# Huntingdonshire Local Plan to 2036 Examination

## **EXAM/46: Representations to the Proposed Main Modifications 2018 Consultation (in Document Order)**

### **Part 3 of 3 – MM21 to MM39**

Huntingdonshire District Council  
February 2018

[Robert Ave flood risk 1.PNG](#)

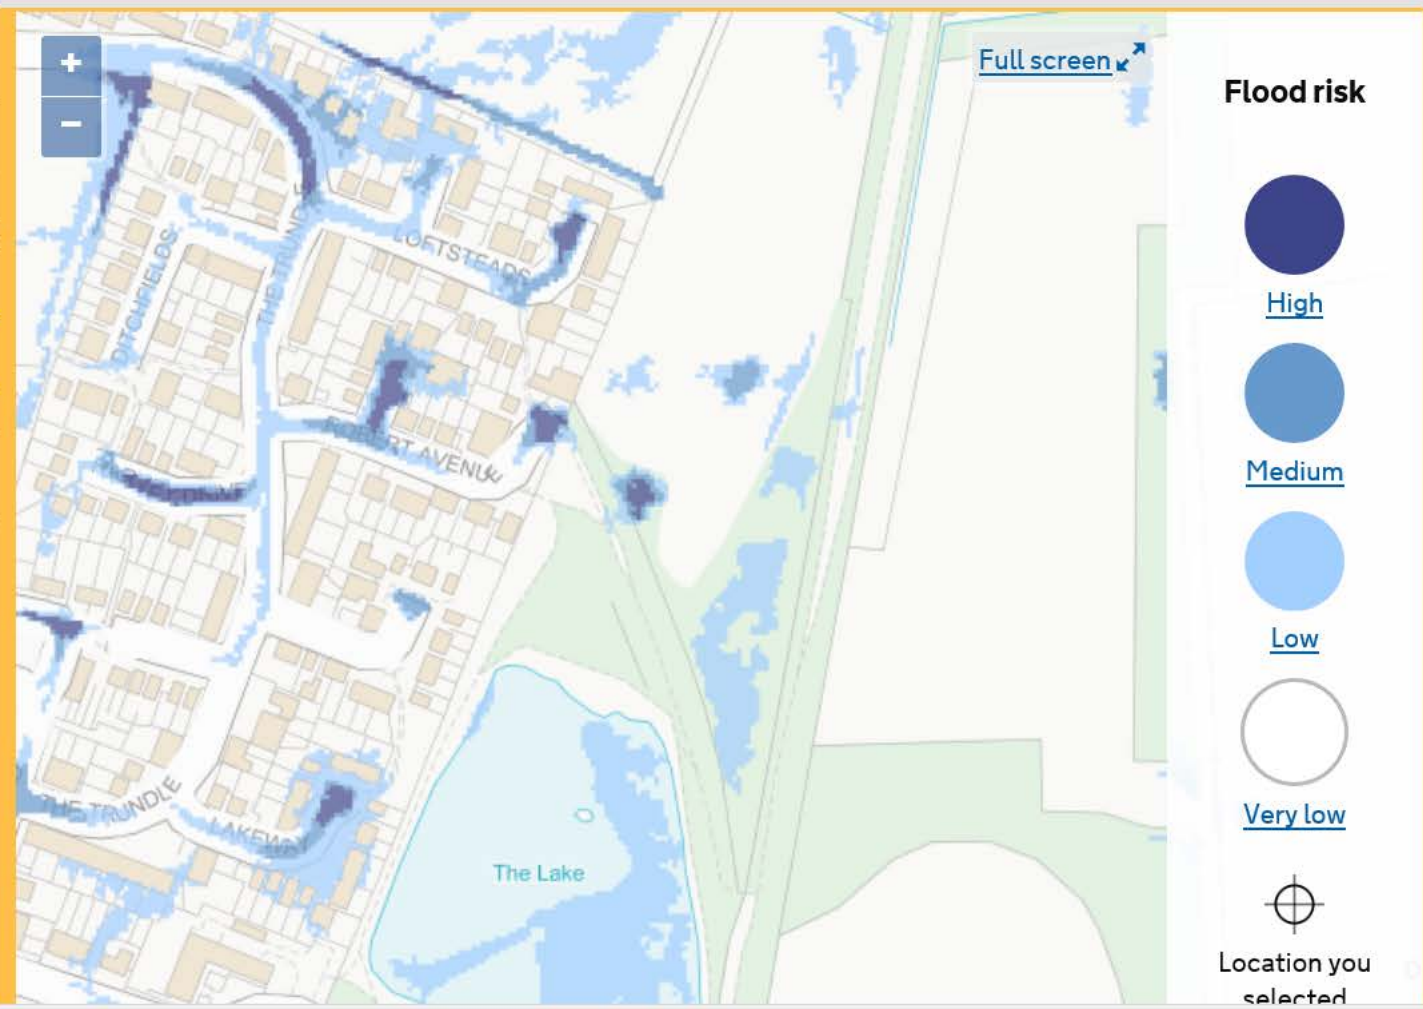
Support Main Modification 32. The proposed development would increase traffic on roads through the village that are already congested at peak times. Robert Avenue would become noisy and un safe with an additional 50 cars moving through it everyday. The loss of habitat next to the local nature reserve would have a negative impact on the wildlife of the reserve and recreational value of the site. This is not in keeping with the objectives of Chapter 8 of the Plan. The school is at capacity there are no school places for the children of the proposed houses. There is a risk of surface water flooding. Environment Agency map attached to support this.
